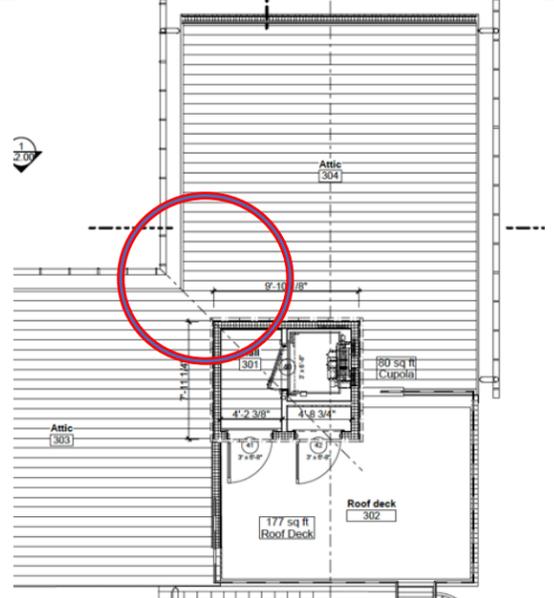
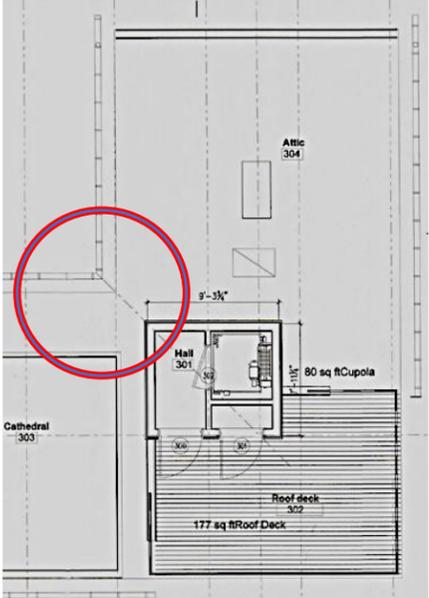
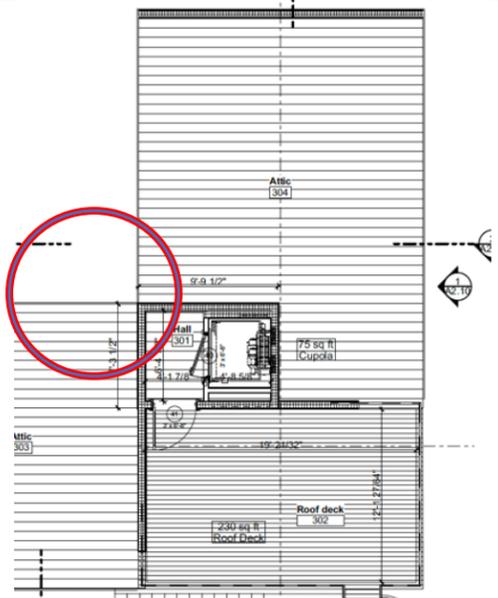
Site Photo 12/20/2019	Approved ZBA #7629 Plans	Plans submitted by applicant for Revoked Zoning Permit # 42345	Denied ZBA #7592 Plans
<p><b>Location of Elevator Shaft</b></p> <p>The elevator shaft has been constructed in the same location as the denied ZBA #7592 plans.</p> <p>This is not in the location that was approved by ZBA #7627.</p> <p>Plans submitted for the Revoked Zoning Permit #42345 also do not show the elevator shaft in this location.</p> <p>Since the elevator shaft has been pulled forward, it is likely that the roof top deck is larger than approved, as seen in the denied ZBA #7592 plan.</p>				
<p><b>New Side Entry</b></p> <p>A side entry has been constructed that is inconsistent with ZBA #7627 approval.</p> <p>Plans submitted for the Revoked Zoning Permit #42345 do not show this landing either.</p> <p>The spiral staircase that was approved per ZBA #7627 is no longer present in the field or on the plans submitted for the Revoked Zoning Permit.</p>

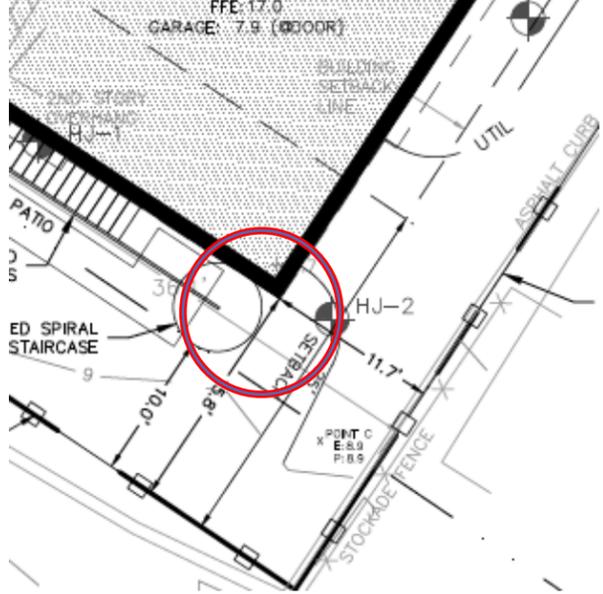
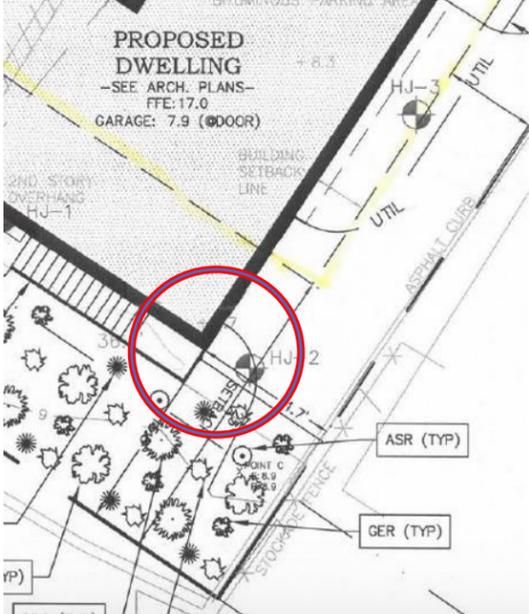
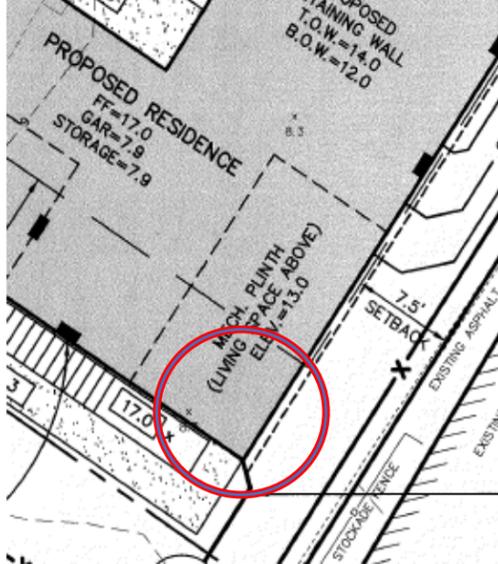
Site Photo 12/20/2019	Approved ZBA #7629 Plans	Plans submitted by applicant for Revoked Zoning Permit # 42345	Denied ZBA #7592 Plans
<p><b>Chimney</b></p> <p>A chimney has been constructed is inconsistent with ZBA #7627 approval, adding a lot of bulk to the building. Instead, the approved plans show a two-story porch.</p> <p>Plans submitted for the Revoked Zoning Permit #42345 show a chimney, as do the denied ZBA #7592 plans.</p>				
<p><b>Windows</b></p> <p>All windows, type and location, have been installed inconsistent with the ZBA #7627 approval.</p> <p>Plans submitted for the Revoked Zoning Permit #42345 show the same location as constructed on the rear elevation, but throughout the building changes have been made. See other photos.</p>

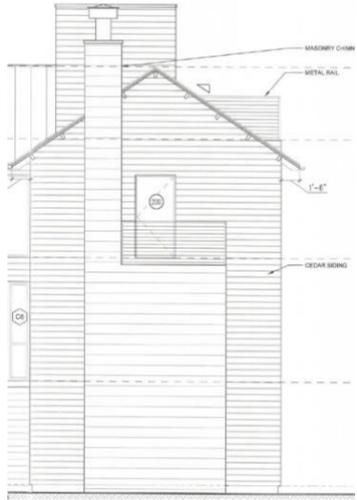
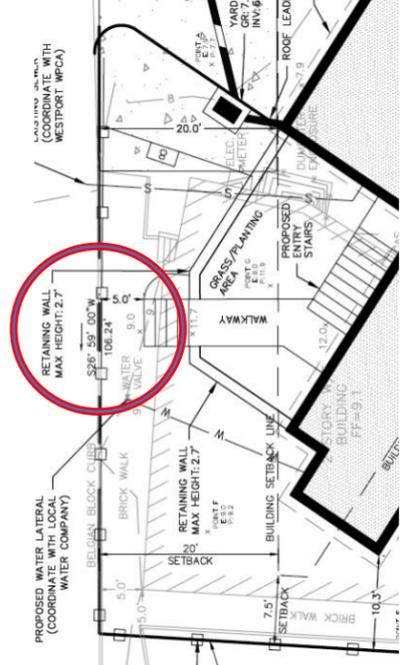
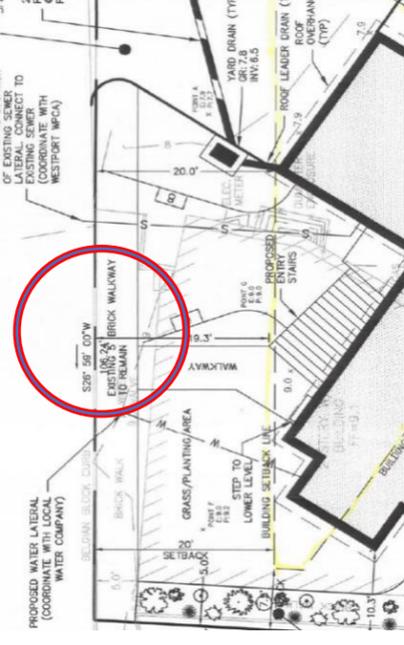
Site Photo 12/20/2019	Approved ZBA #7629 Plans	Plans submitted by applicant for Revoked Zoning Permit # 42345	Denied ZBA #7592 Plans
<p><b>Front Entry</b></p> <p>The front entrance that has been constructed is inconsistent with ZBA #7627 approved plans.</p> <p>Plans submitted for the Revoked Zoning Permit #42345 show a similar configuration as to what is in the field, though it is not clear as the staircase that exists is temporary.</p> <p>Fill and retaining walls were approved in ZBA application #7629. which served to “ground” the building. Currently the building has been constructed on piers.</p>				
<p><b>Front wall and sidewalk</b></p> <p>The wall was not present on site on 12/19/20 and 12/20/2019 as documented by staff photos.</p> <p>The wall is not present in either the approved ZBA #7629 plan or the Revoked Zoning Permit.</p> <p>A condition of ZBA #7629 approval was that the brick walkway be retained. The walkway is currently asphalt and the width is not equivalent to what was on the ZBA approved plans.</p>	 <p style="text-align: center;">*This Photo taken 3/29/2020.</p>

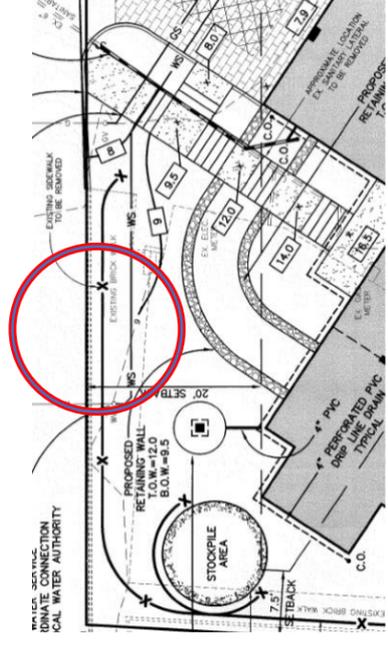
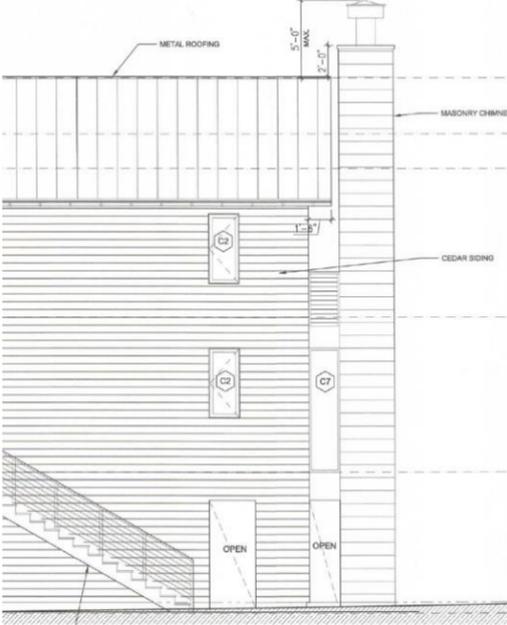
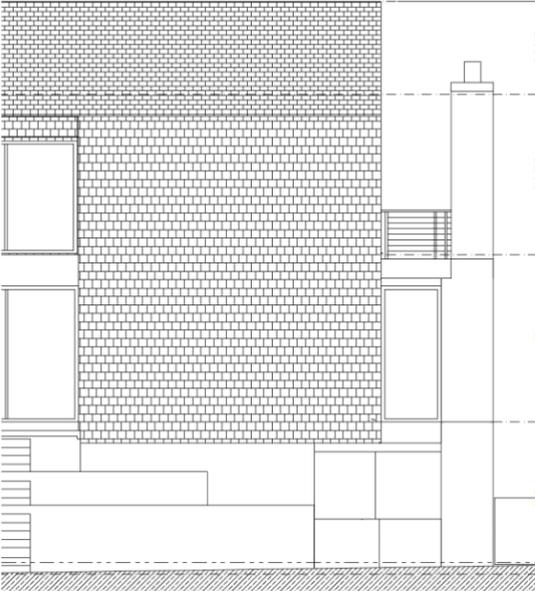
Site Photo 12/20/2019	Approved ZBA #7629 Plans	Plans submitted by applicant for Revoked Zoning Permit # 42345	Denied ZBA #7592 Plans
<p><b>Building Materials</b></p> <p>The applicant has made significant changes to the materials from the approved ZBA #7629 plans. The approved ZBA plans have a cedar wood roof and painted cedar shingle siding. There is a stone veneer foundation. The windows are divided lites and there are shutters for the windows.</p> <p>The plan the applicant submitted for the Revoked Zoning Permit has horizontal cedar siding, a masonry chimney and metal roofing. The photograph reveals that the location of the windows and detailing are not consistent with either the Revoked Zoning Permit or the ZBA approved plans</p>	 <p style="text-align: center;">*This photo taken 6/17/2020</p>			
<p><b>Mechanical Units</b></p> <p>The approved plan ZBA #7629 and the Revoked Zoning permit shows mechanicals going under the house.</p> <p>The applicant states that they now intend to put the mechanicals in the side yard.</p>
